Turkey Point Units 3 and 4  
Docket Nos. 50-250 and 50-251  
Renewed Facility Operating License Nos. DPR-31 and DPR-41

Subject: License Amendment Request No. 237, Application to Revise  
Technical Specification Figure 3.1-2, Boric Acid Tank Minimum Volume

License Amendment Request No. 237

Application to Revise Technical Specification Figure 3.1-2, "Boric Acid Tank Minimum Volume"

Figure 3.1-2  
 BORIC ACID TANK MINIMUM VOLUME (1)  
 Modes 1, 2, 3 and 4

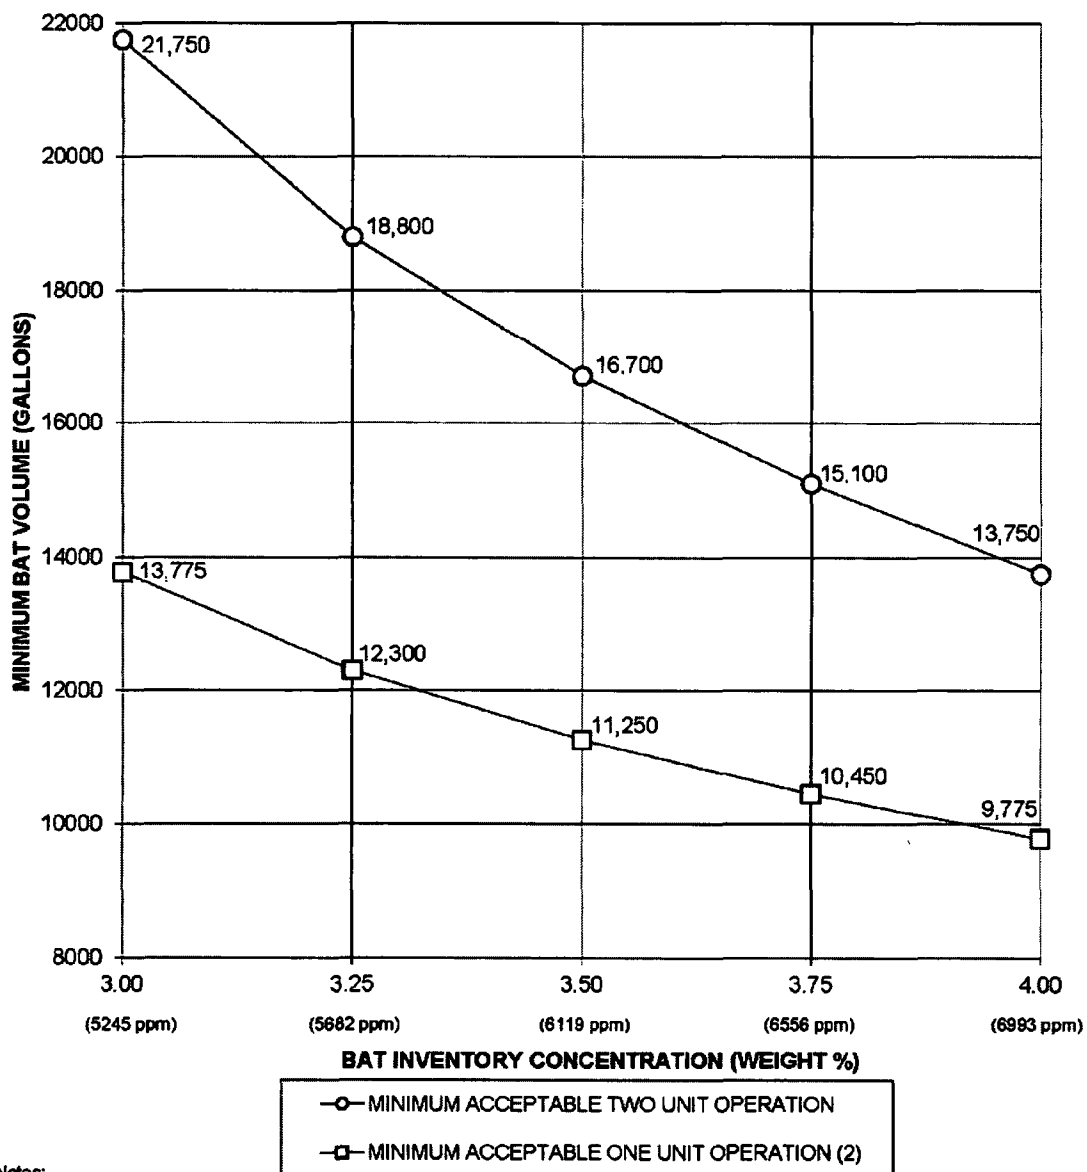
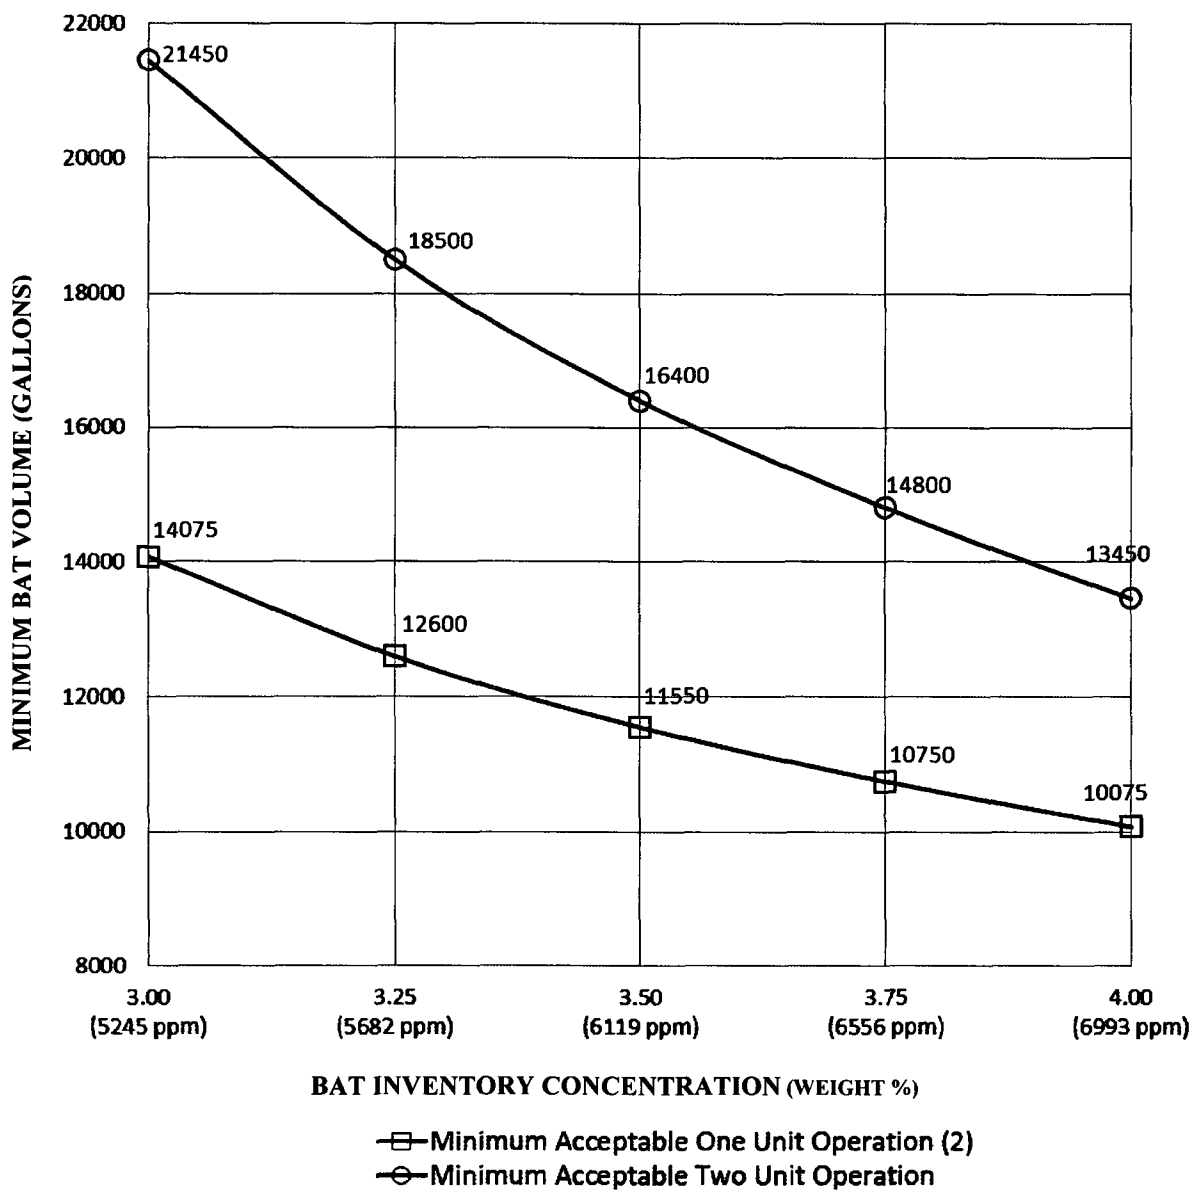
TS Figure 3.1-2 establishes the minimum acceptable BAT volume (gallons) for a given boron concentration, for one unit and two unit operation. The current TS Figure 3.1-2, BAT Minimum Volume was approved under Amendments 249 and 245 in June 2012 (Reference 1). An instrument uncertainty of 600 gallons is included in the BATs' minimum volume curve for one unit operation. Two errors have been identified in the calculation of the minimum acceptable BAT volume for a given boron concentration, for one unit and two unit operation in the current TS Figure 3.1-2.

The current TS Figure 3.1-2 BAT minimum volume curve for two unit operation reflects a 1200 gallons uncertainty. The instrument uncertainty of 600 gallons described above was erroneously doubled to 1200 gallons and included in the BAT minimum volume curve for two unit operation. The BATs are common equipment that serves both units. Consequently, the instrument uncertainty for two unit operation should not have been counted twice when establishing the minimum acceptable BAT volume curve.

Additionally, an error was identified in the calculation of BAT volume measurement uncertainty used to establish the minimum acceptable BAT volume for the current TS Figure 3.1-2. The total loop uncertainty (TLU) for the BAT instrumentation that monitors BAT level is calculated using the square-root-sum-of-the-squares (SRSS). There are three BAT instrument loops that monitor BAT level; one for each tank. As described above, the three BATs are cross-tied together effectively creating one common tank for both Units 3 and 4. However, the conversion of the TLU into equivalent tank volume uncertainty (in gallons) was erroneously calculated based on the volume of a single BAT. The calculation should have considered the volume of the common tank for both units comprised of three BATs cross-tied together. As a result, the calculated TLU (in gallons) was underestimated. This error resulted in the instrumentation uncertainty increasing from 600 gallons to 900 gallons. This increase in the instrumentation's uncertainty value requires changes to the minimum acceptable BAT volume for a given boron concentration, for one unit and two unit operation shown on TS Figure 3.1-2.

The current TS Figure 3.1-2 minimum acceptable BAT volume curve for one unit operation reflects a 600 gallons instrument uncertainty. FPL proposes to revise TS Figure 3.1-2 by increasing the minimum acceptable BAT volume curve for one unit operation by 300 gallons to

As previously discussed, the current TS Figure 3.1-2 minimum acceptable BAT volume curve for two unit operation erroneously reflect a 1200 gallons uncertainty (a 600 gallons uncertainty doubled). To correct this, the minimum acceptable BAT volume curve for two unit operation has been reduced by 600 gallons. Due to the other error identified in the calculation of BAT volume uncertainty, the BAT volume measurement uncertainty for two unit operation needs to be further revised by 300 gallons, making the final revised uncertainty 900 gallons. Therefore, the minimum acceptable BAT volume curve for two unit operation needs to be reduced by a total of 300 gallons (from 1200 to 600 to 900 gallons). The current TS Figure 3.1-2 BAT minimum volume curve for two unit operation is more restrictive than the proposed corrected values.

FPL proposes to revise TS Figure 3.1-2 to reflect a correction to the instrument uncertainty calculation. There are no proposed changes to TS 3.1.2.5 Limiting Condition for Operation (LCO) item a.

reflect the revised instrument uncertainty of 900 gallons. This error constitutes a potential non-conservative TS. Pursuant to Administrative Letter 98-10 (Reference 2), administrative controls have been established to assure that the minimum acceptable BAT volume for one unit operation is maintained within the corrected values until the proposed amendment is approved by the NRC and implemented. Review of Turkey Point Units 3 and 4 past operating history since implementation of the current TS Figure 3.1-2 indicates that the units have operated within the proposed minimum acceptable BAT volume curve for one unit operation.

The proposed TS change will not adversely affect plant operation, jeopardize the performance of safety-related equipment, or otherwise compromise public health and safety. Therefore, the proposed change to TS Figure 3.1-2, which increases the BAT minimum acceptable volume curve for one unit operation by 300 gallons and decreases the BAT minimum volume curve for two unit operation by 300 gallons, is justified.

Figure 3.1-2  
BORIC ACID TANK MINIMUM VOLUME (1)  
Modes 1, 2, 3 and 4

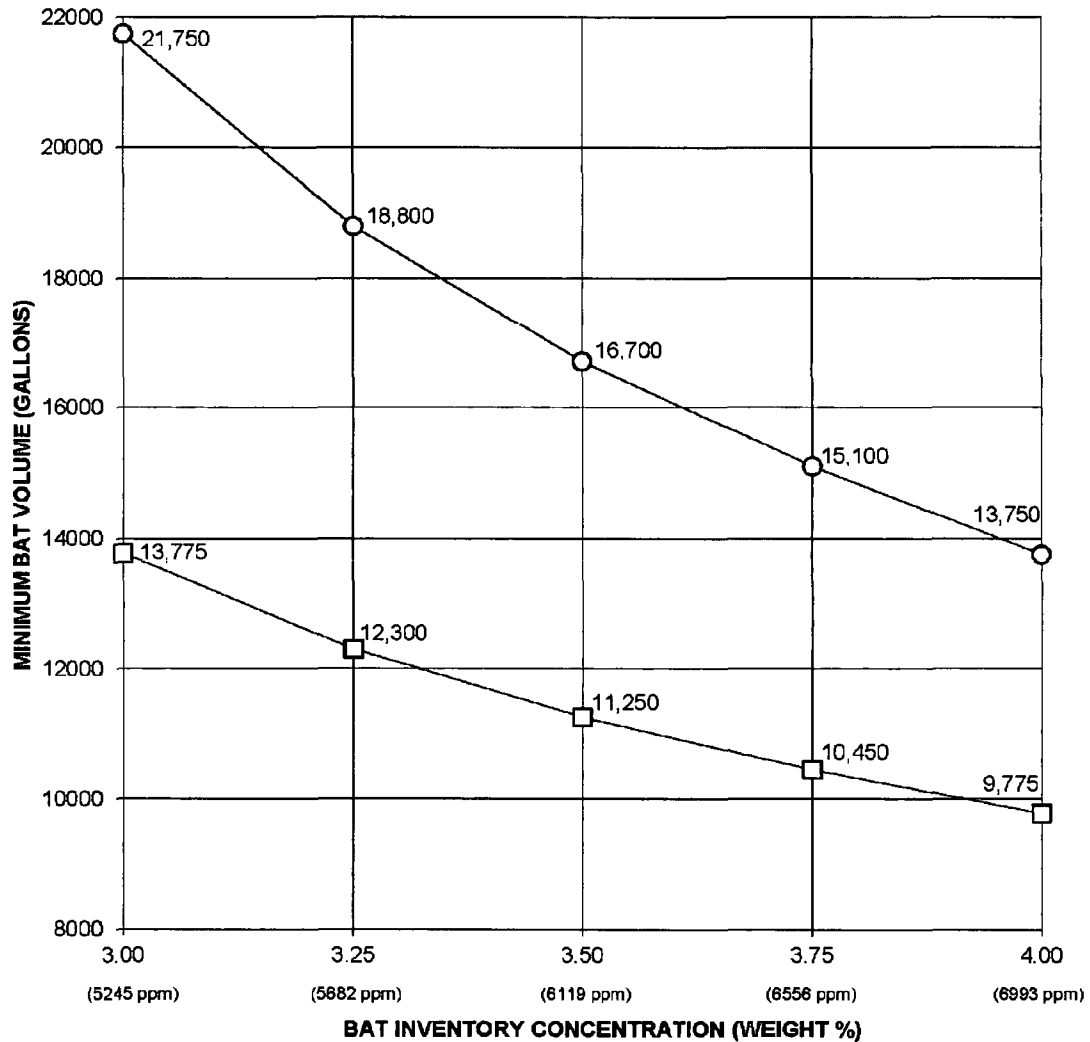
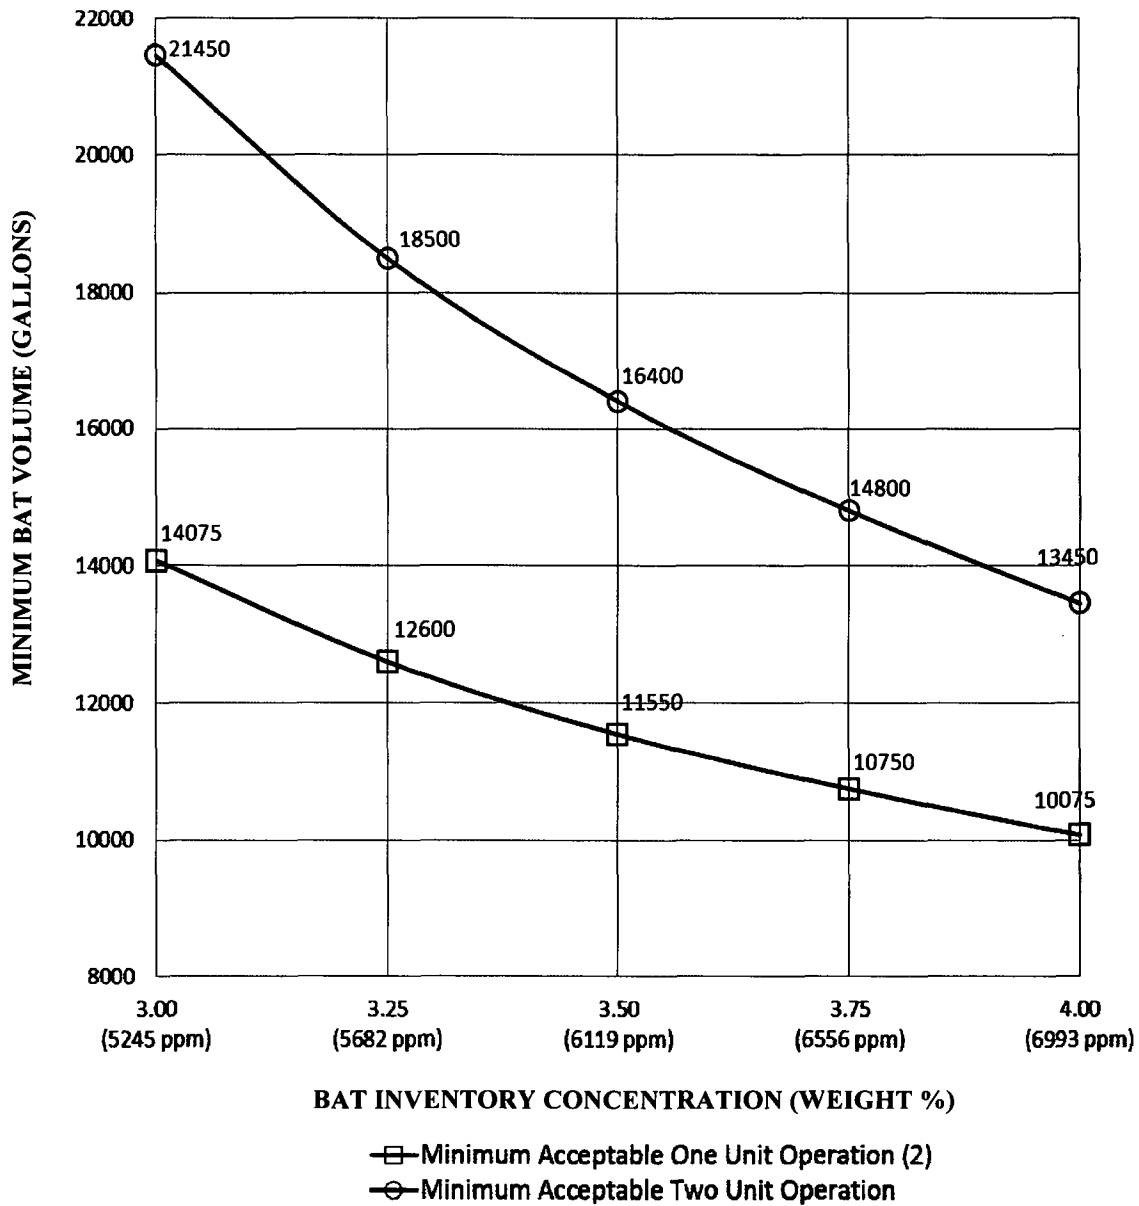
**Delete Figure 3.1-2 and  
Insert A**

### INSERT A
